Contract #: 04-0120F4Cty: SF/ALA Rte: 80 PM: 13.2/13.9File #: 69.25B**QUALITY ASSURANCE -- NON-CONFORMANCE REPORT****Location:** Changxing Island, Shanghai, P.R. China**Report No:** NCR-000856**Prime Contractor:** American Bridge/Fluor Enterprises, a JV**Date:** 04-Oct-2010**Submitting Contractor:** Zhenhua Port Machinery Company, Ltd (ZPMC), Changxing Island**NCR #:** ZPMC-0818**Type of problem:**

Reference Description: Fit Lug Removal without Engineer's approval located at West Shaft (109m) and South Shaft (119m)

Job Name: SAS Superstructure
Document No: 05.03.06-000813

NCR PROPOSED RESOLUTION

Report No: NCR-000853

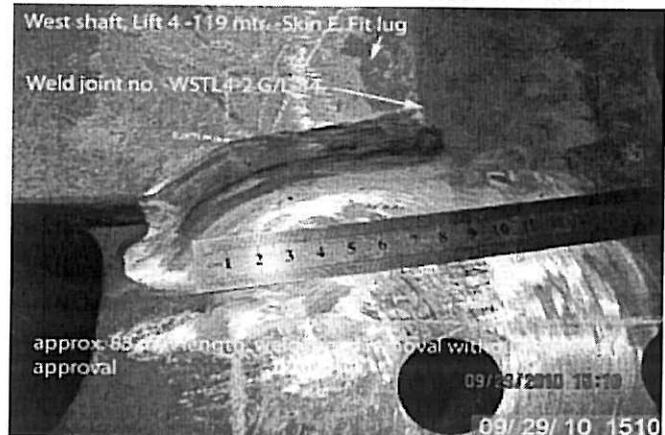
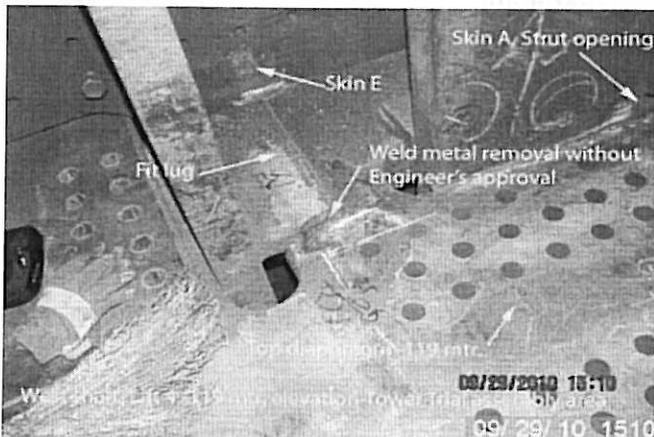
Reference Description: Skin E, Fit lug-119m have been cut without Engineer's approval

- Approximately 85mm in length, (25mm wide) of Fit Lug that was welded to the top diaphragm. Skin Plate E was removed without engineer approval.

- The Fit lug found in top diaphragm, skin E, Lift 4- 119 mtr, West Tower,
- The Weld removed has the following Weld ID: WSTL4-2 C/L-86.

AWS D1.5 Section 3.7.5- "The Engineer shall be notified before improperly fitted and welded members are cut apart."

Report No: NCR-000855

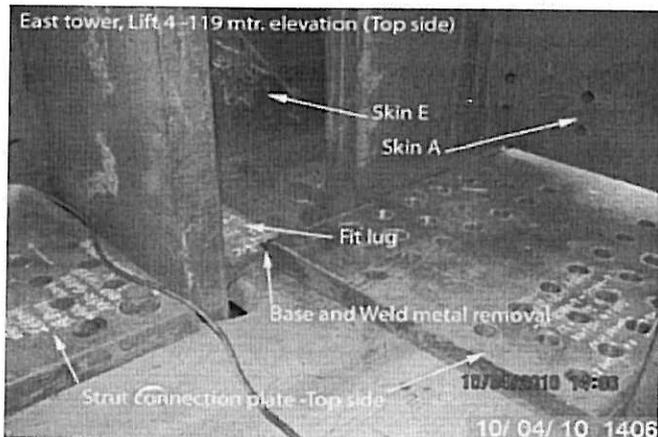
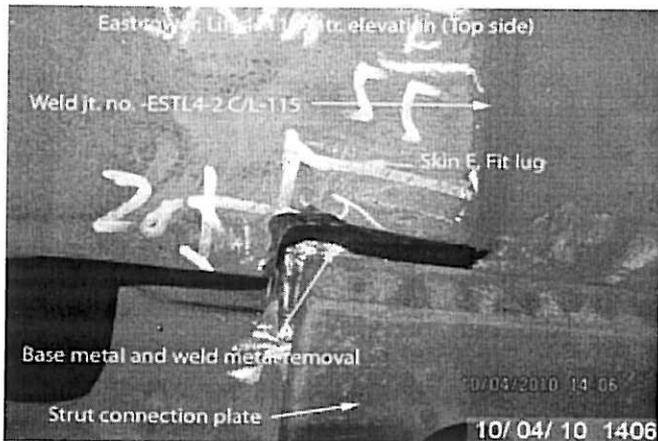
Reference Description: East and North Shaft at 119m: Skin E - Fit Lug removal without Engineer's approval

-Approx. 55 mm length, 25 mm width, weld metal and base metal removal observed in Skin E, fit lug weld without Engineer's approval.

-The fit lug found in East Tower, Lift 4- 119m top diaphragm.

-The weld joint no. of the fit lug weld found to be ESTL4-2 C/L-115.

-Approx. 50 mm length, 35 mm width, weld metal and base metal removal observed in Skin E, fit lug weld without engineer's approval.

-The fit lug found in North Tower, Lift 4- 119m top diaphragm.

-The weld joint no. of the fit lug weld found to be NSTL4-1 C/L-98.

AWS D 1.5 Section 3.7.4 – “Prior approval of the Engineer shall be obtained for repairs to base metal (other than those required by 3.2), repair of major or delayed cracks, repairs to ESW and EGW welds with internal defects, or for a revised design to compensate for deficiencies.”

AWS D1.5 Section 3.7.5- “The Engineer shall be notified before improperly fitted and welded members are cut apart.”

This proposed resolution is accepted with action pending. The retrofit work per TC-RFI 0166 for the fit lug on the North Shaft shall be completed and related NDT reports for Weld No. NSTL4-1C/L-98 submitted and reviewed.

Report No: NCR-000856

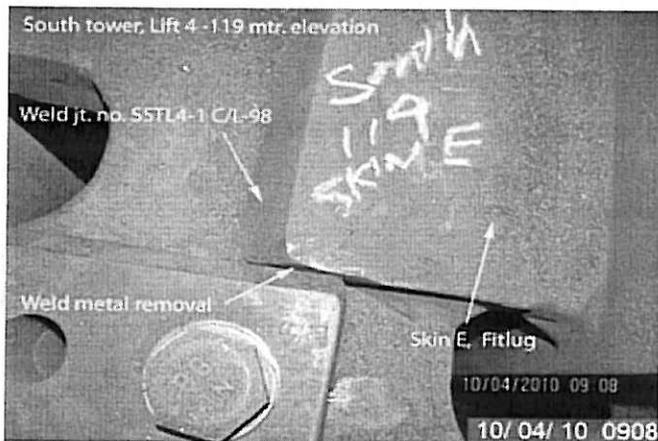
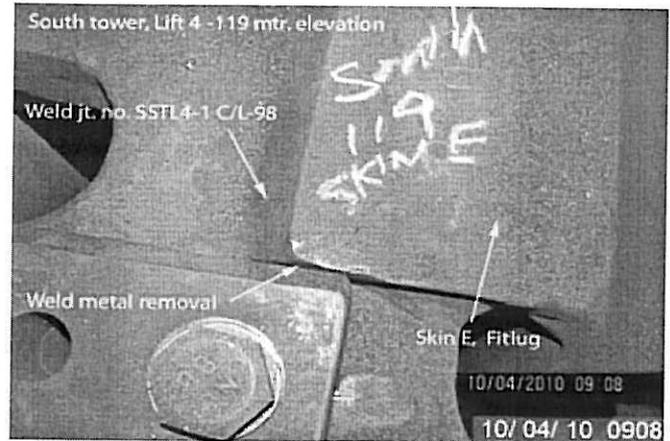
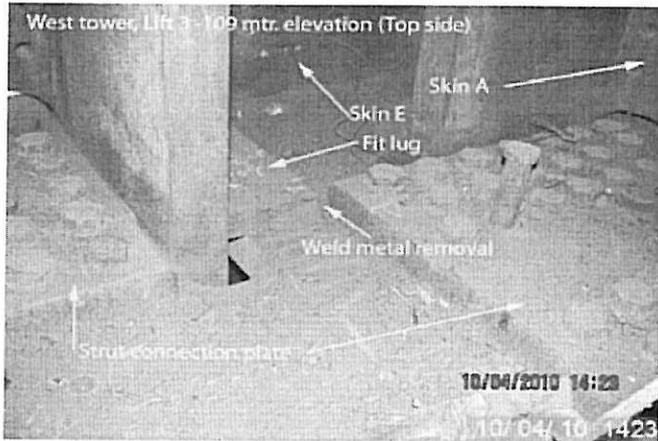
Reference Description: Fit Lug Removal without Engineer's approval located at West Shaft (109m) and South Shaft (119m)

- Approx. 50mm length, weld metal removal observed in Skin E, fit lug weld, without Engineer's approval.
- The fit lug found in West Tower, Lift 3- 109m top diaphragm.
- The weld joint no. of the fit lug weld found to be WSTL3-4 I / K-128.

- Approx. 55mm length, weld metal removal observed in Skin E, fit lug weld, without Engineer's approval.
- The fit lug found in South Tower, Lift 4- 119m top diaphragm.
- The weld joint no. of the fit lug weld found to be SSTL4-1 C/L-98.

AWS D1.5 Section 3.7.5- "The Engineer shall be notified before improperly fitted and welded members are cut apart."

Contractor will grind the cut corner as per the Designer's requirements. ie. tapering the cut corner, and perform MT. Contractor will provide the NDT report to prove the welds are acceptable. Contractor will discuss with foreman about the issue, and instruct the foreman/QC, prior notification to Engineer is required to any retrofit work being performed.

Contractor ground the cut corner as per Designer's request. Contractor provided the NDT report to prove the welds are acceptable. The foreman/QC was warned and instructed that the Engineer has to be notified and approval has to be sought prior to any retrofit work.
